**SUBJECT: NEW VEHICLE DEMONSTRATION / DELIVERY HOLD -  
Compliance Recall 19C02**  
Certain 2019 Model Year Ranger Vehicles  
Brake Transmission Shift Interlock Override – Wire Routing

**NEW VEHICLE DEMONSTRATION / DELIVERY HOLD**  
**Compliance Recall 19C02**  
Certain 2019 Model Year Ranger Vehicles  
Brake Transmission Shift Interlock Override – Wire Routing

## CERTAIN 2019 MODEL YEAR RANGER VEHICLES — BRAKE TRANSMISSION SHIFT INTERLOCK OVERRIDE – WIRE ROUTING

FIGURE 8

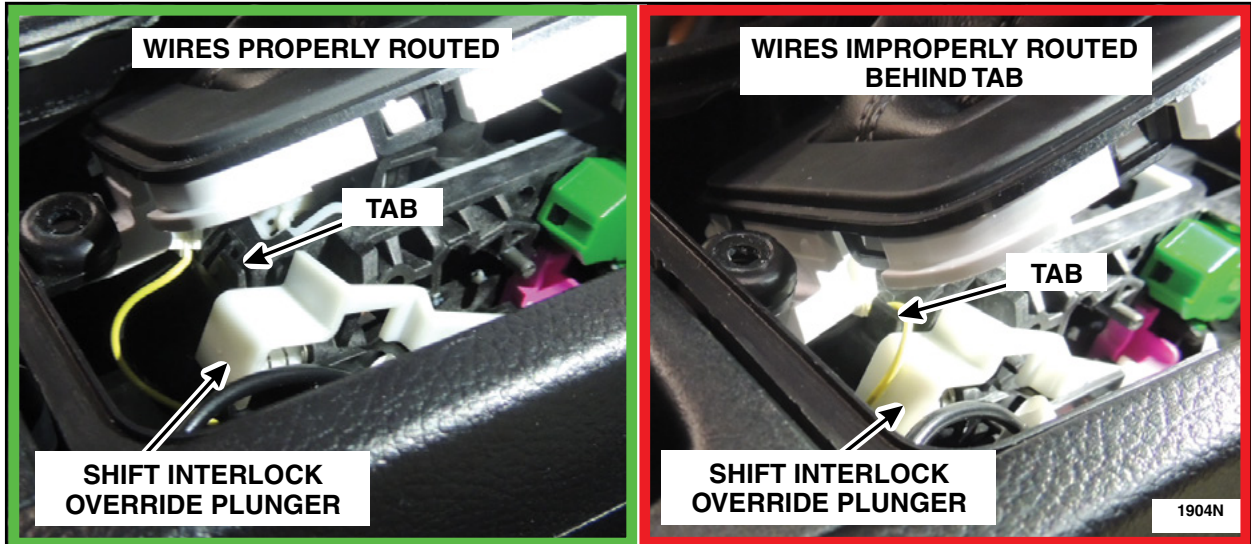
8. Relocate the improperly routed yellow and/or black wires, that were holding down the shift interlock override plunger, to the correct position. See Figure 8.

**FIGURE 9**

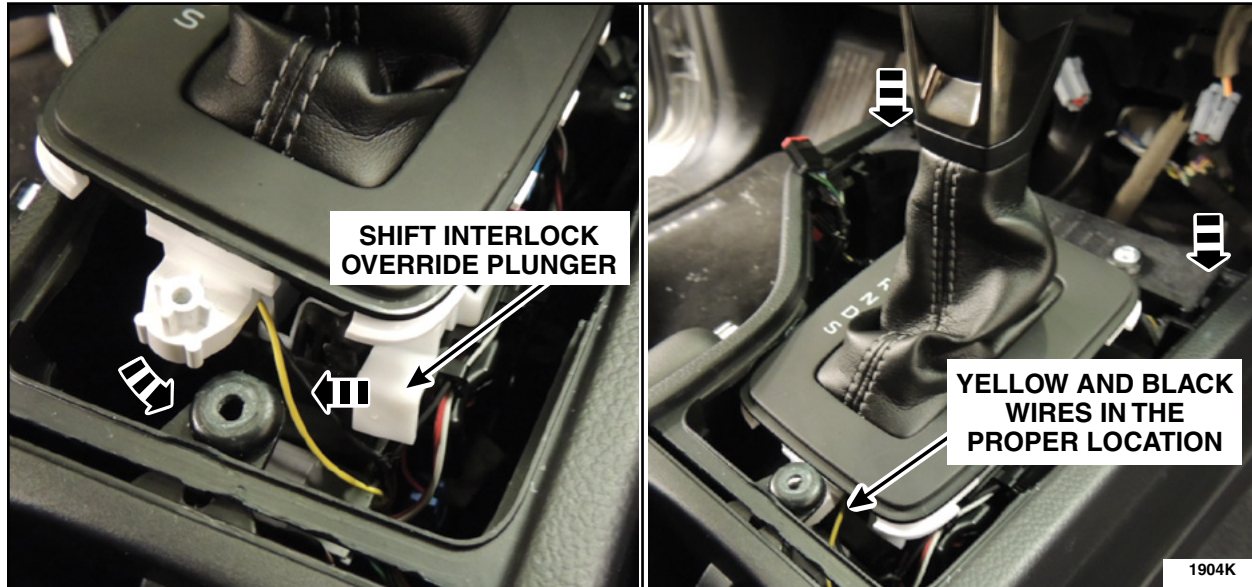
9. Guiding the wires away from the shift interlock override plunger, reposition the shift selector lever bezel assembly and secure the floor console bracket into the floor console. See Figures 7 and 9.
